**DATE: April 19, 2016**  
**REGULAR**  
**ITEM # 18a**  
**RESOLUTION 2016-34**

**AGENDA ITEM:** Inwood 3rd Addition Residential Subdivision – Final Plat and Final PUD

# INWOOD THIRD ADDITION

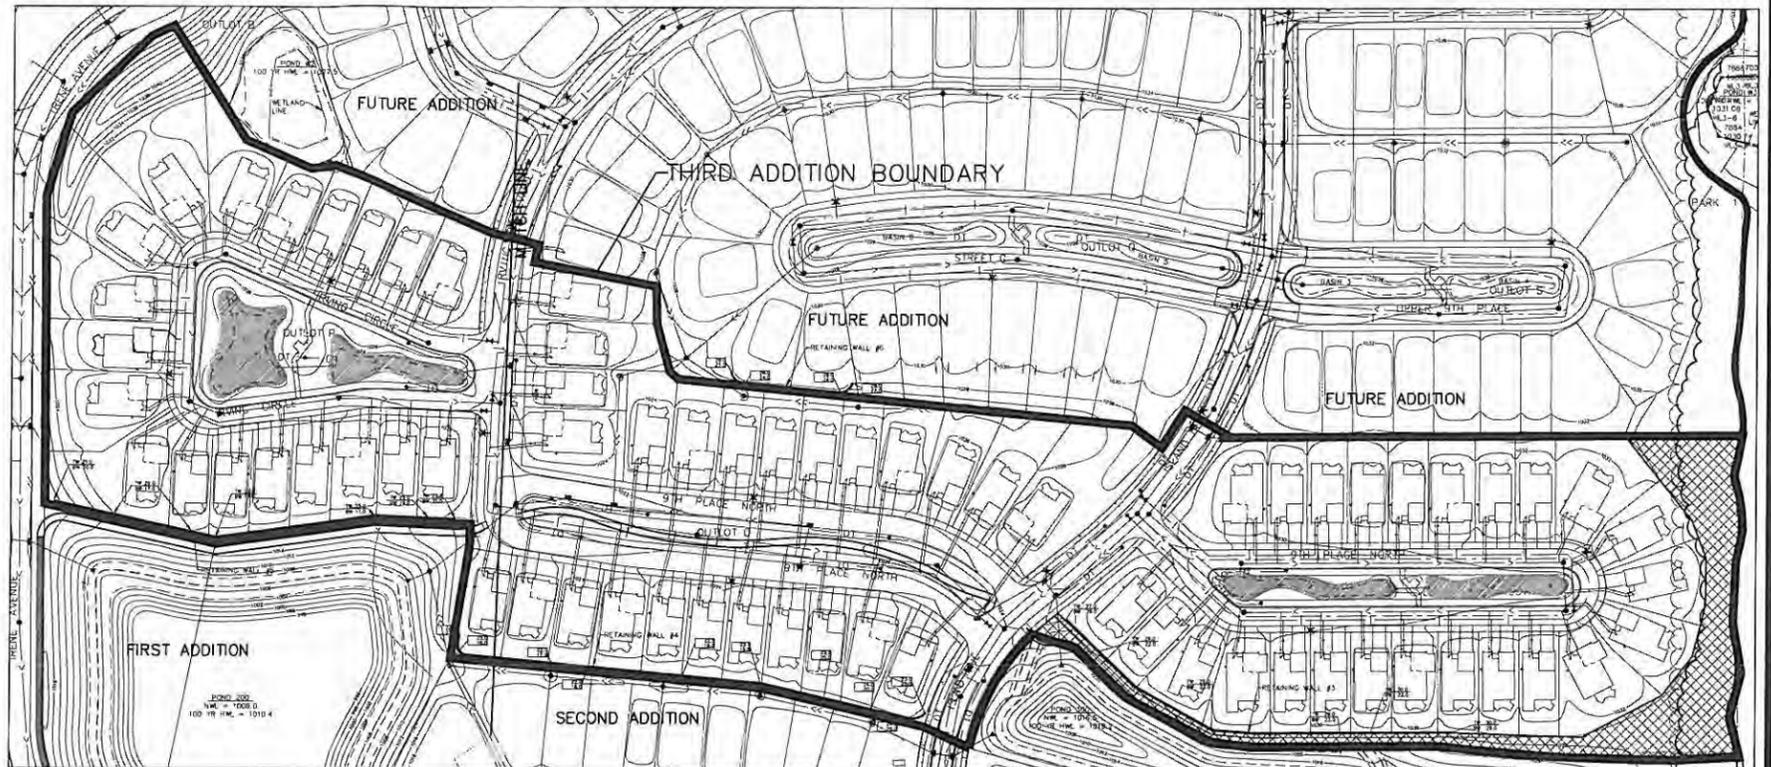
15. Revise infiltration basin details. The rock mulch specified does not appear to be consistent with the grading/drainage details and plans which note: "Plant Native Plants Tolerant of Inundation and Drought". There are concerns related to maintenance, functionality of the basins without the water cleansing benefit of plantings, the sterile nature of these spaces and lack of biodiversity / wildlife habitat as currently proposed.

7. Provide a design section of infiltration basin details. I created a quick hand sketch and attached for some ideas / notes of what we discussed at our sit down meeting. Once this is created please update landscape plans notes to be consistent with new graphic. The plans most recently submitted specify Geogrid which is a structural fabric typically utilized for structural reinforcement in a retaining wall system. We discussed utilizing Geotextile Fabric. Please specify an exact product specification as part of the detail... if you would like some suggestions we are happy to redline detail once it is resubmitted and point you to an acceptable product line for this application so you can further your research selection with your client and make a final selection.
